Addendum No.: 2

York Correctional Institution Central Plant and Piping Distribution

BI – JA – 465

The following clarifications are applicable to drawings and specifications for the project referenced above.

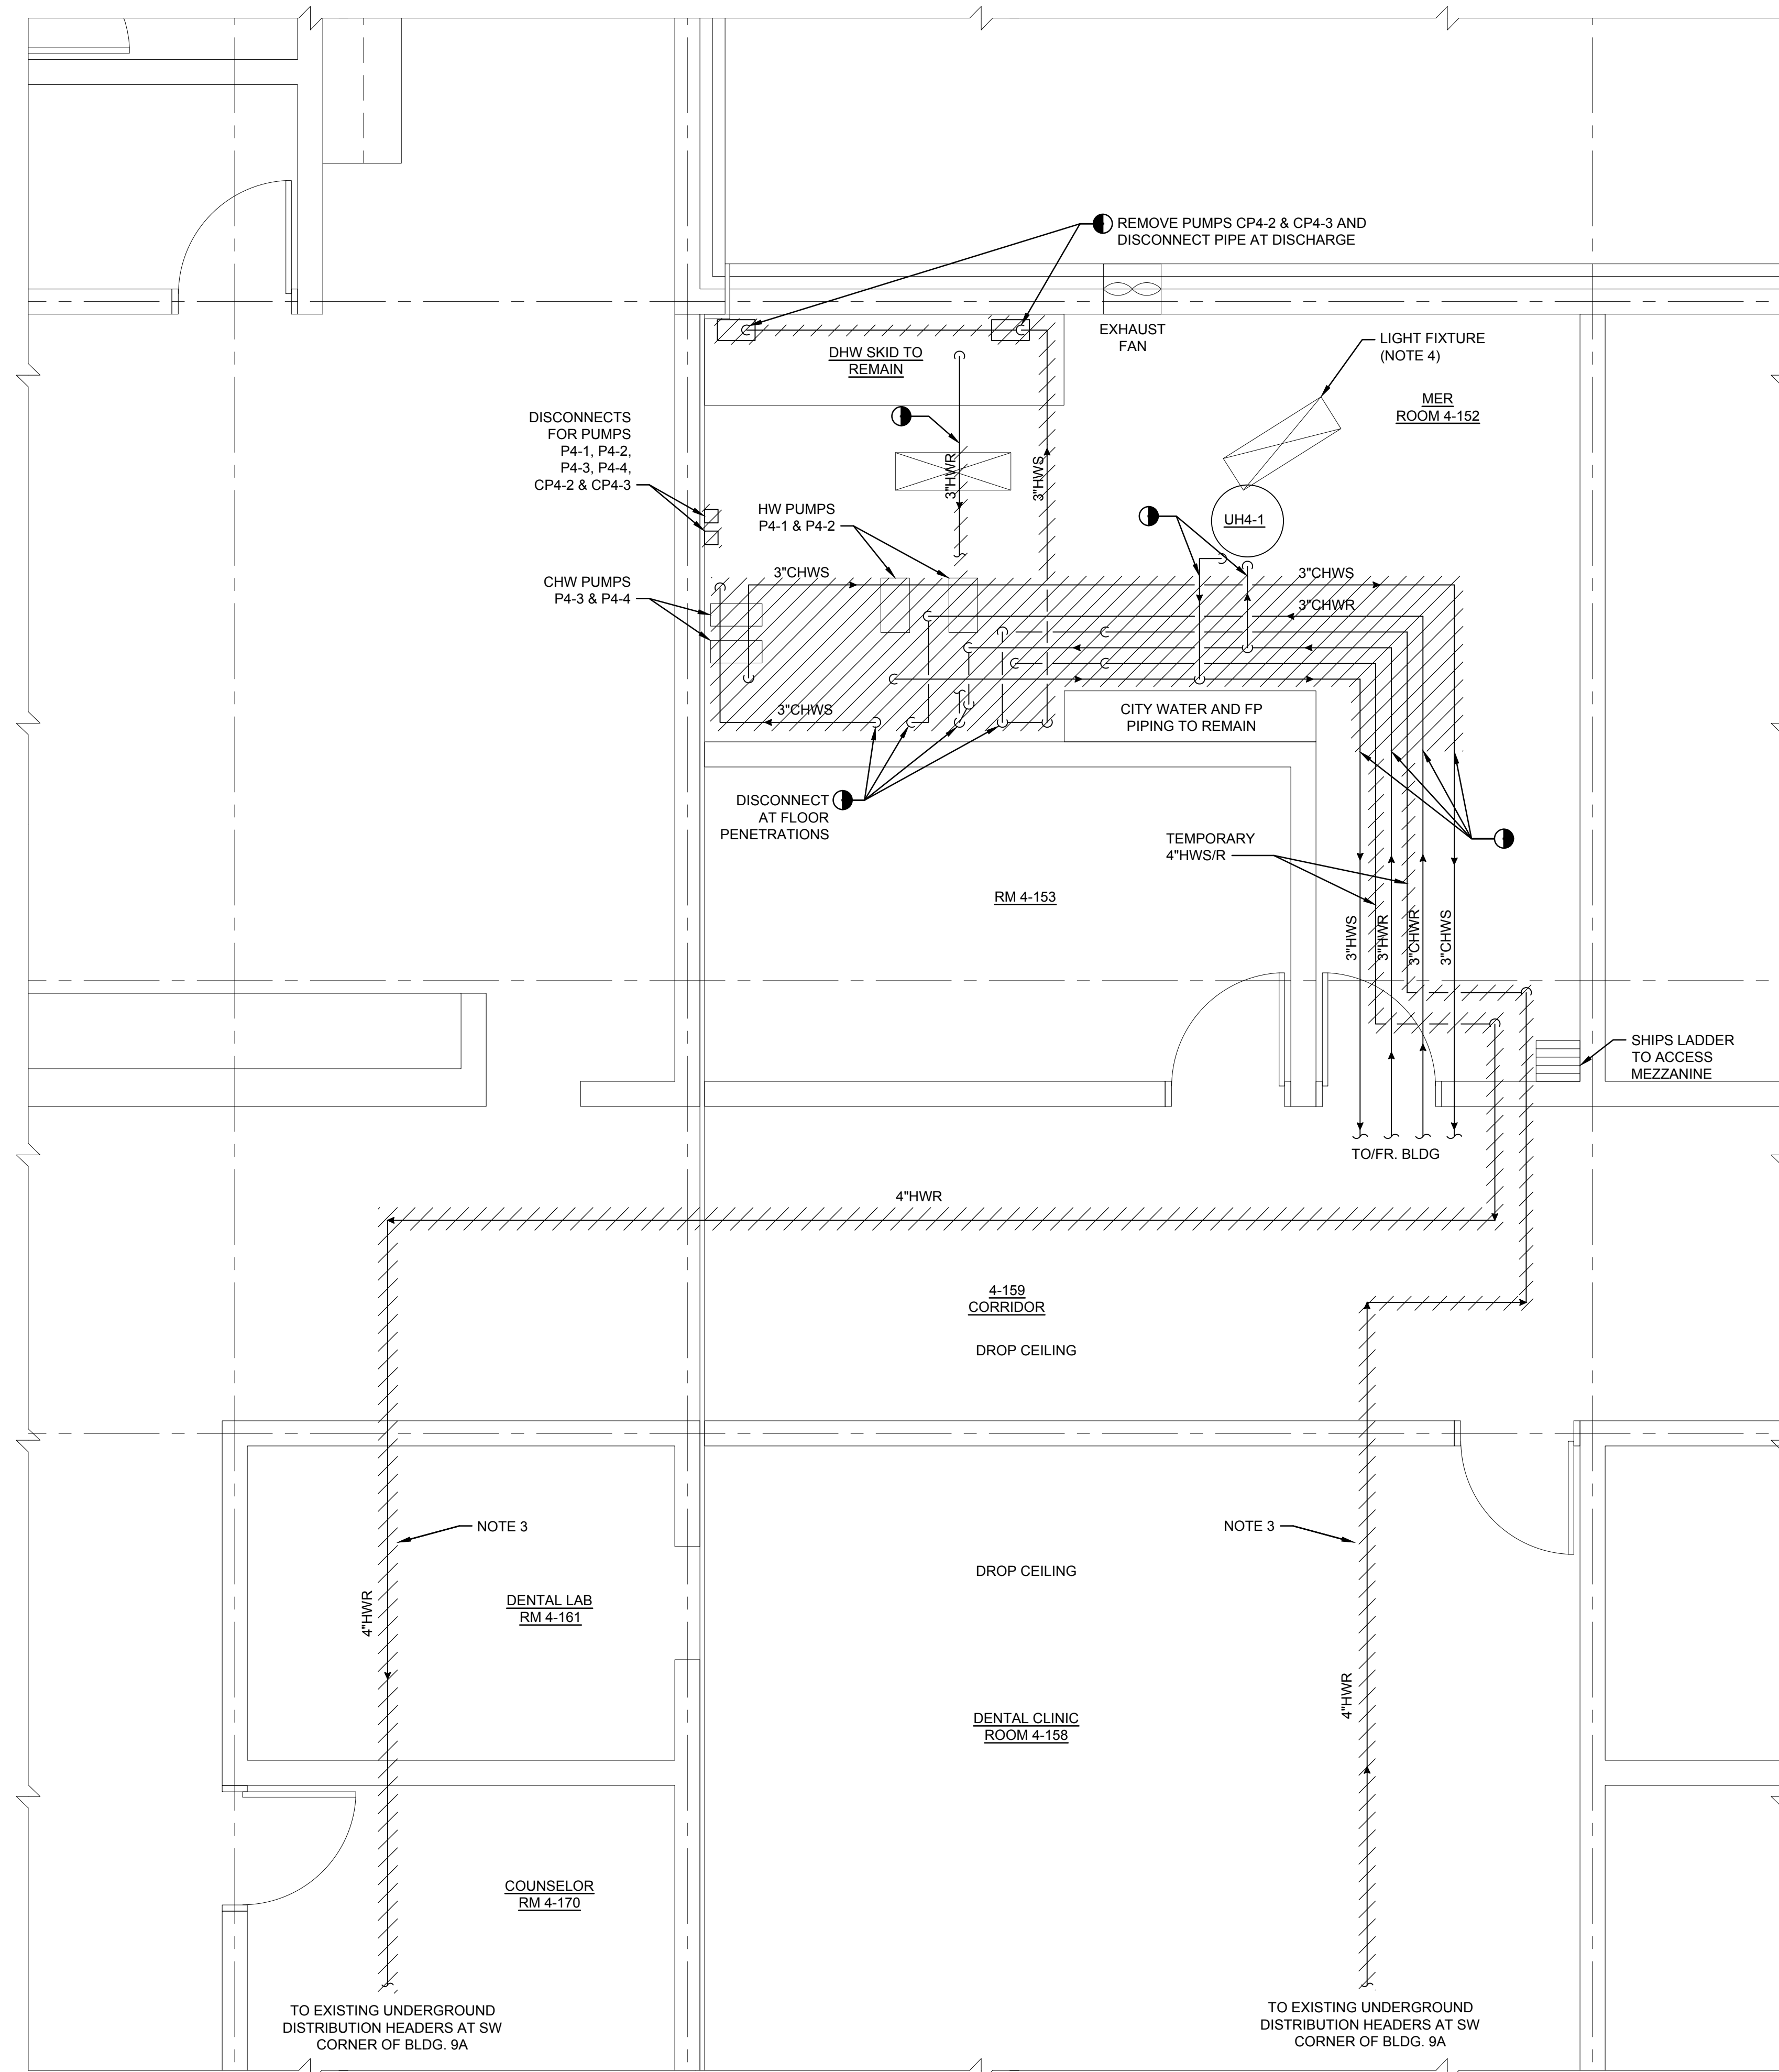
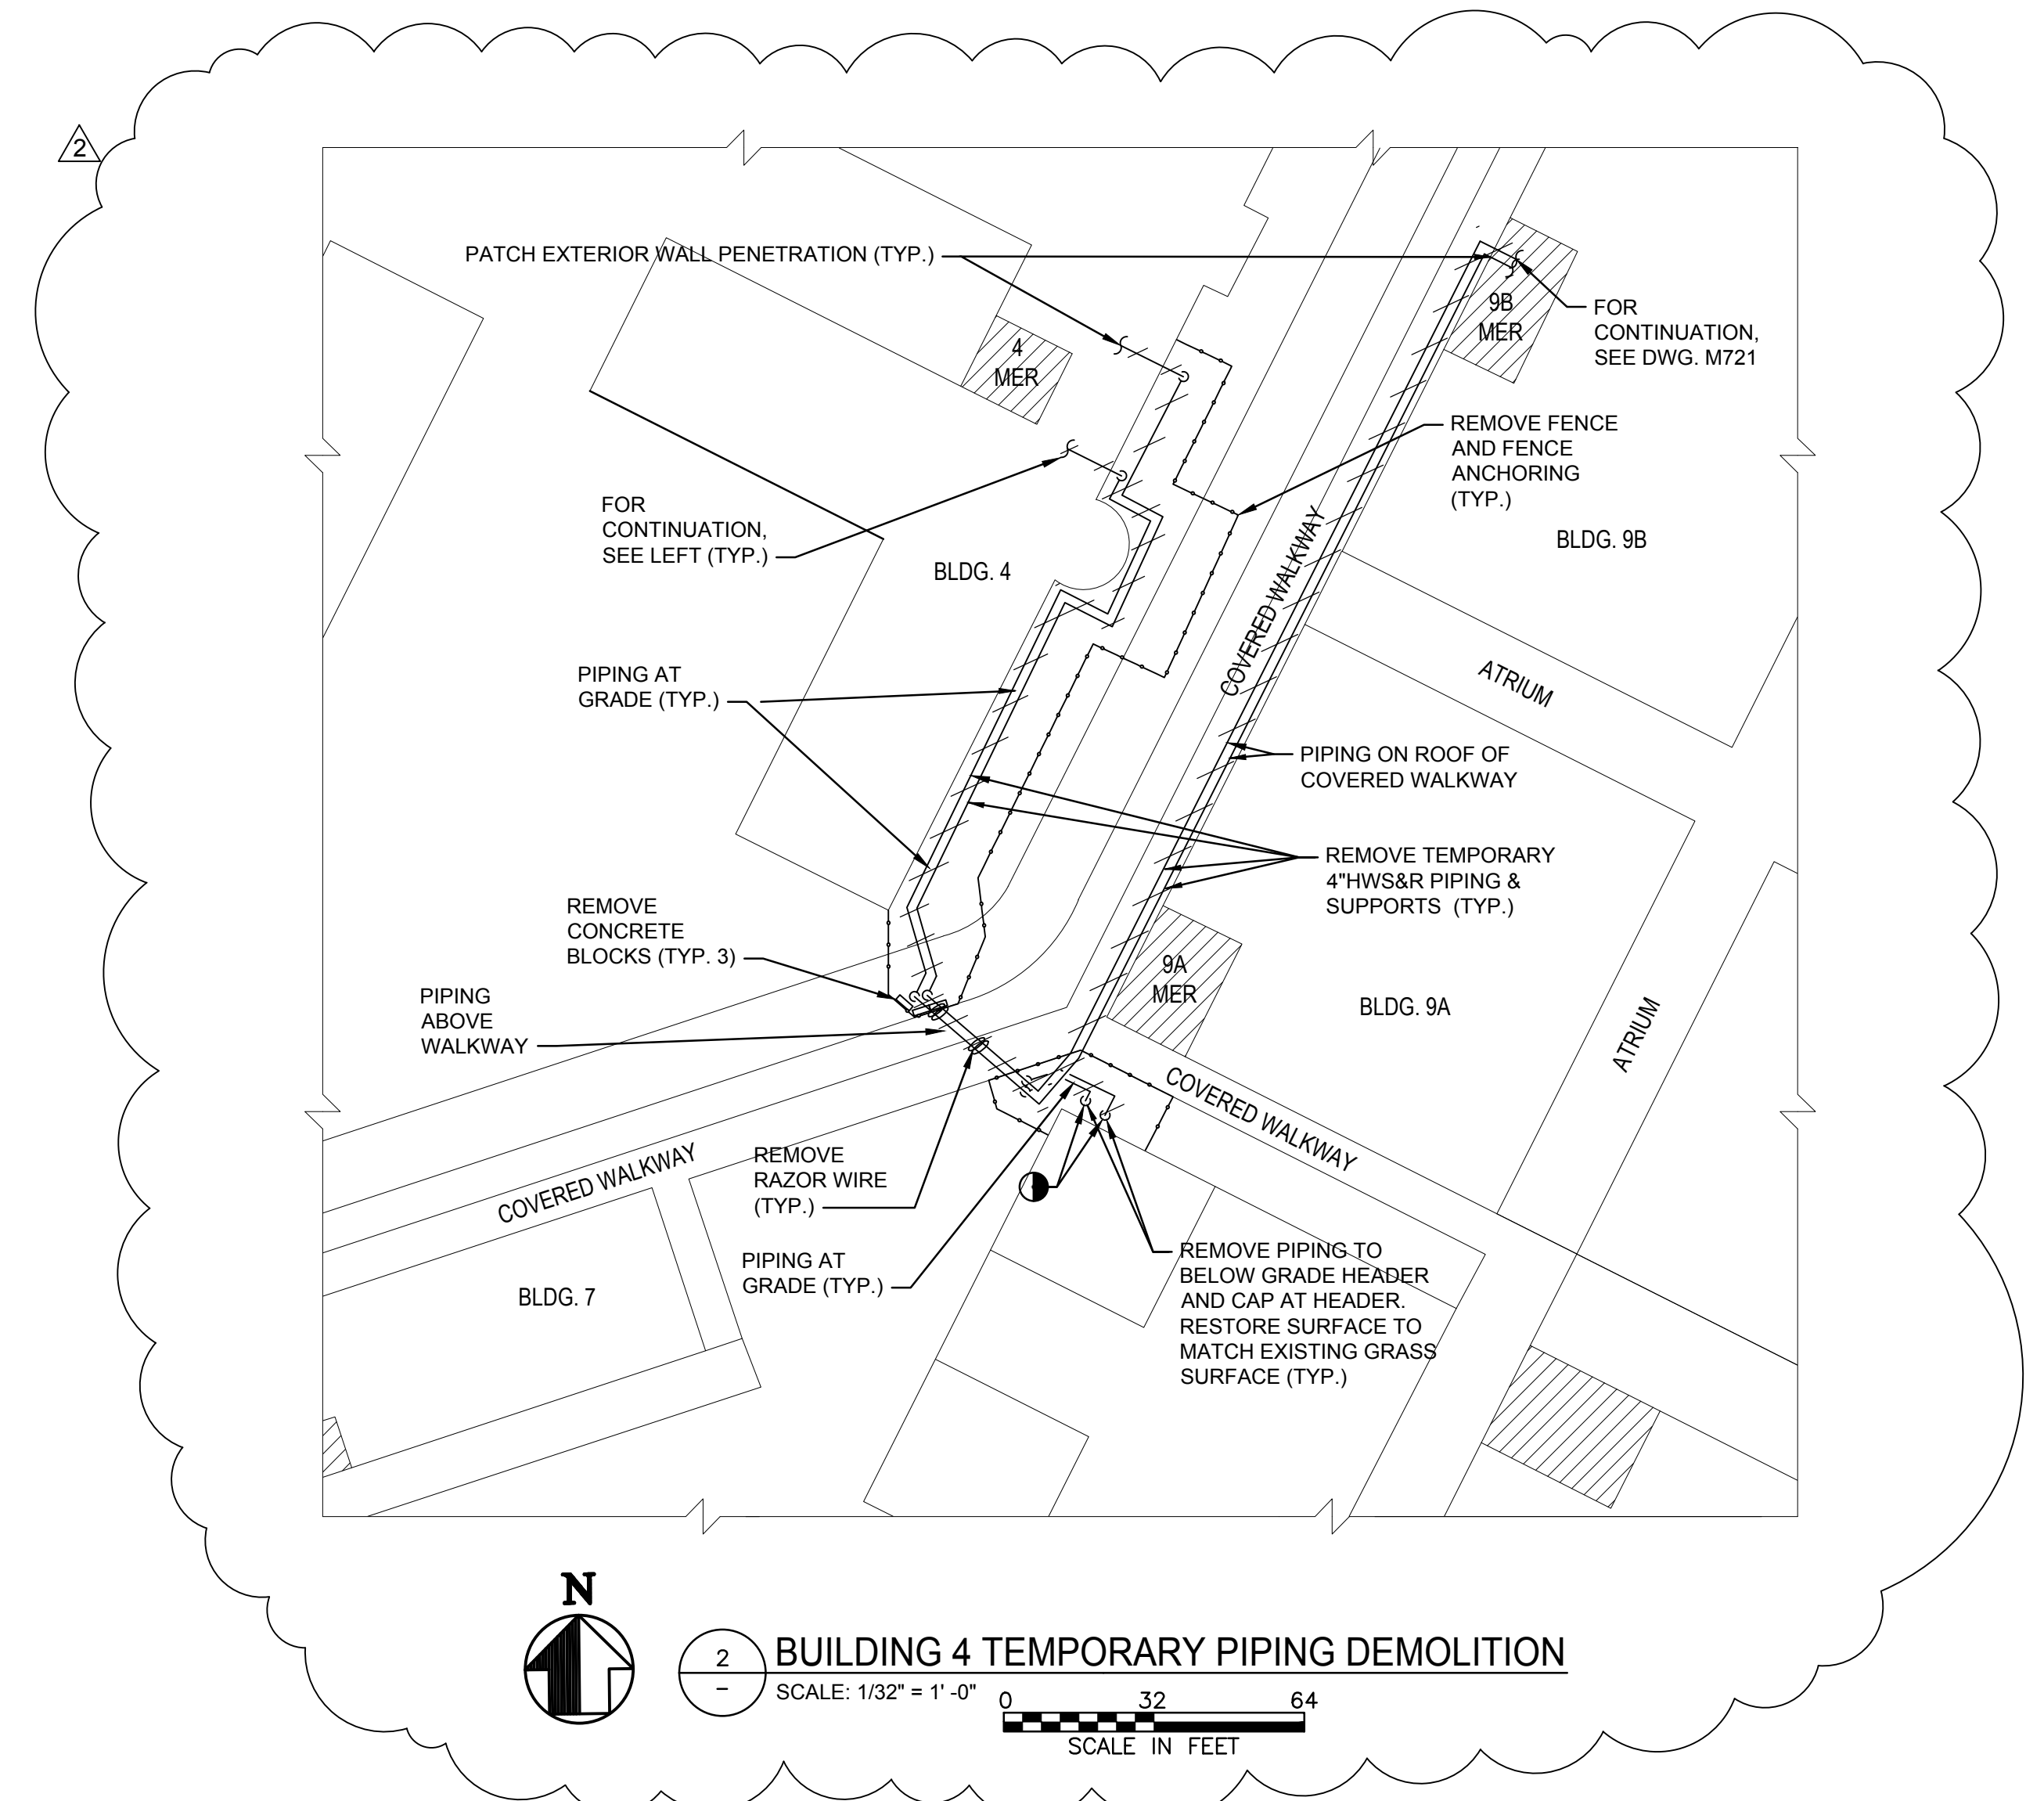
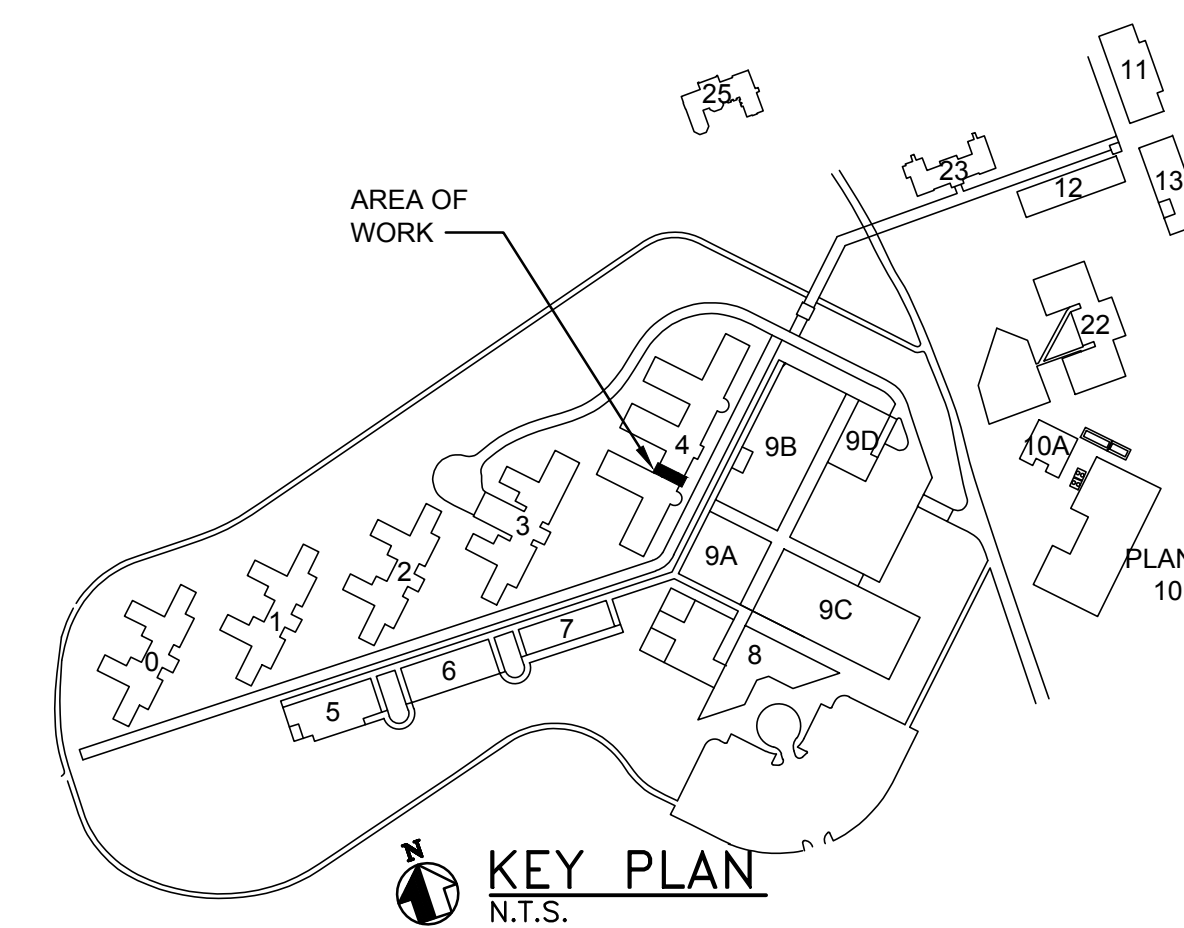
Drawing M709 Building 4 Part Plan Demolition

**ADDED** part plan showing removal of temporary 4"HWS&R piping

D 5 ULTRASONIC FLOWMETER/ENERGY METER  
NTS

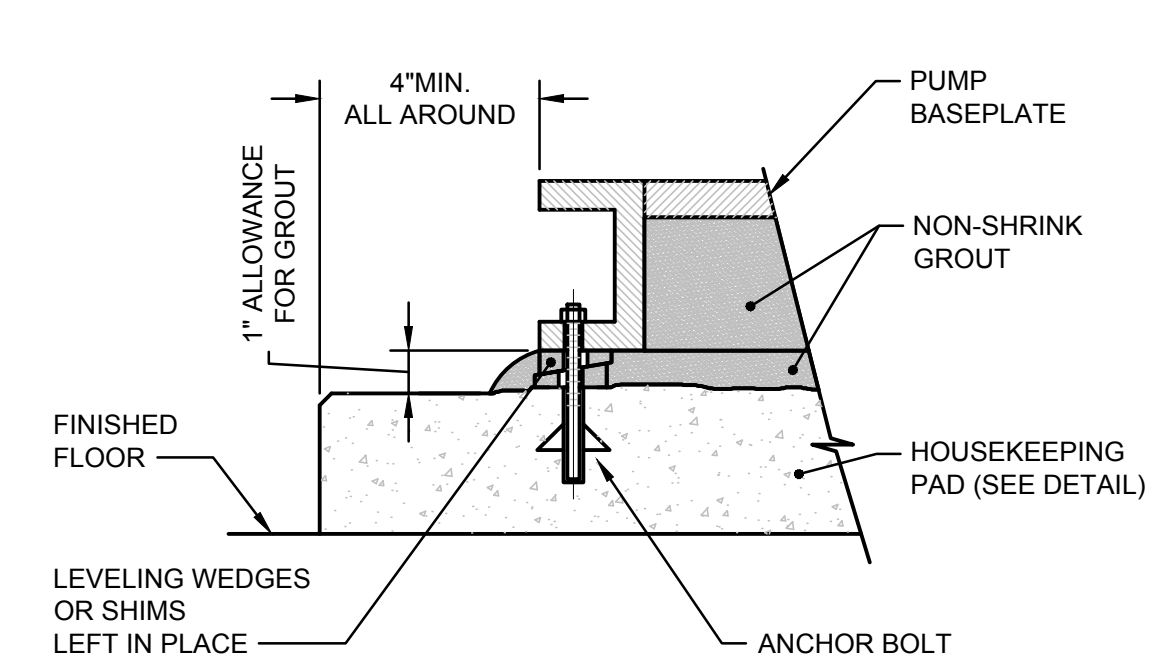
**UPDATED** detail 5 to include Energy Meter; updated detail 9 title for clarification

**D 7** BREECHING ROOF PENETRATION  
NTS

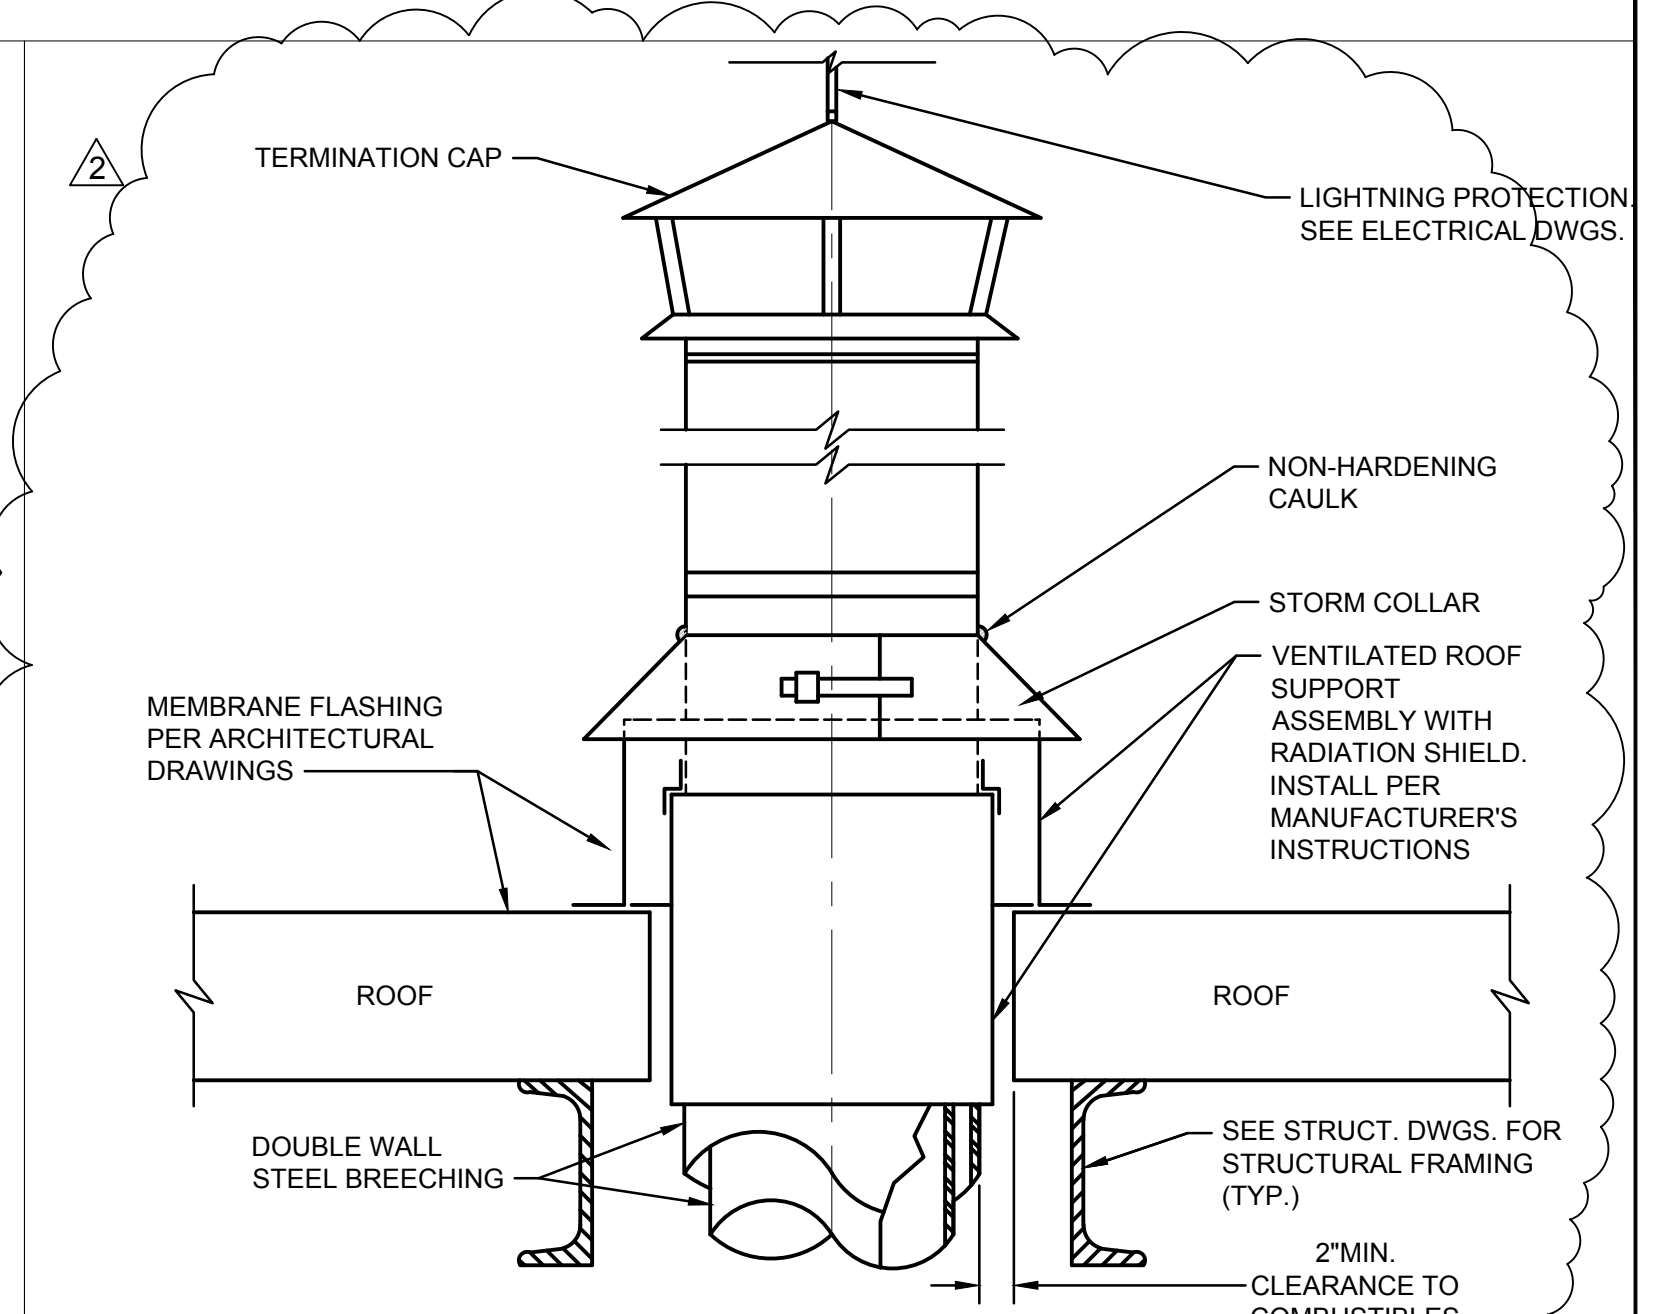
**ADDED** boiler stack roof penetration detail
